REQUEST FOR PROPOSAL "RFP" NO. PS20200107

SUPPLY AND DELIVERY OF LED LUMINAIRES & INTELLIGENT STREET LIGHT CONTROLS SYSTEM

QUESTIONS AND ANSWERS NO. 4

ISSUED ON: May 29, 2020

TYPICAL WIRING CONNECTION STREET LIGHTING ONLY

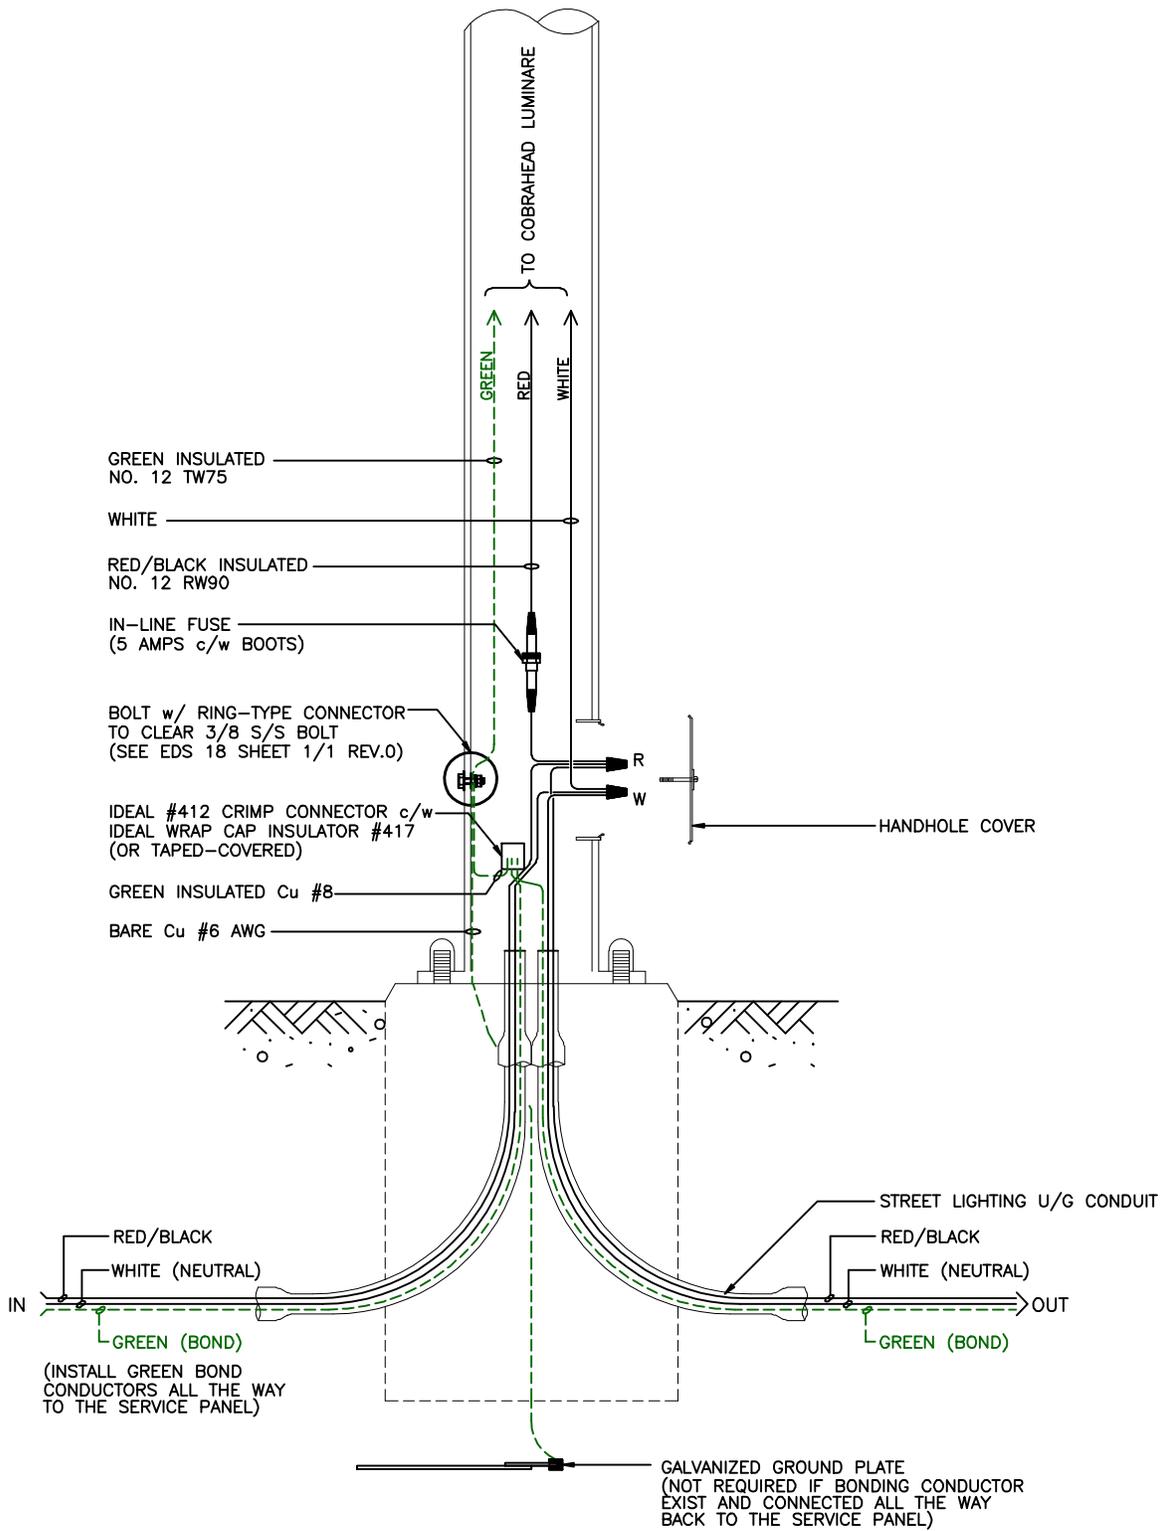
Q4.	Please provide the specific wiring diagram on how the pole is to be bonded from the pole arm to the fixture's terminal block?
A4.	Refer to the attached COV drawing, LDS-1.4.
Q5.	<p>Re: CS-5 Is network micro-segmentation available where the sensors connect to the gateways and gateways connect to the internet to enhance the security of each IoT device by segmenting them from other devices or other consumers on the same network? For instance, provide a secure and reliable segmented network that connects multiple vendors streetlight controllers in a way that different controllers would be completely segmented? Please provide details</p> <p>What is the goal/purpose of the micro-segmentation of devices? Is the city trying to segregate vendors devices so they can manage them independently within a common rf mesh network (logical separation) or do they actually want to completely isolate different vendor devices such that they do not participate in the same RF mesh - i.e. will never use the same communication pathways (physical separation)?</p>

Attached drawing, PS20200107 - LDS-1.4 - for QA4
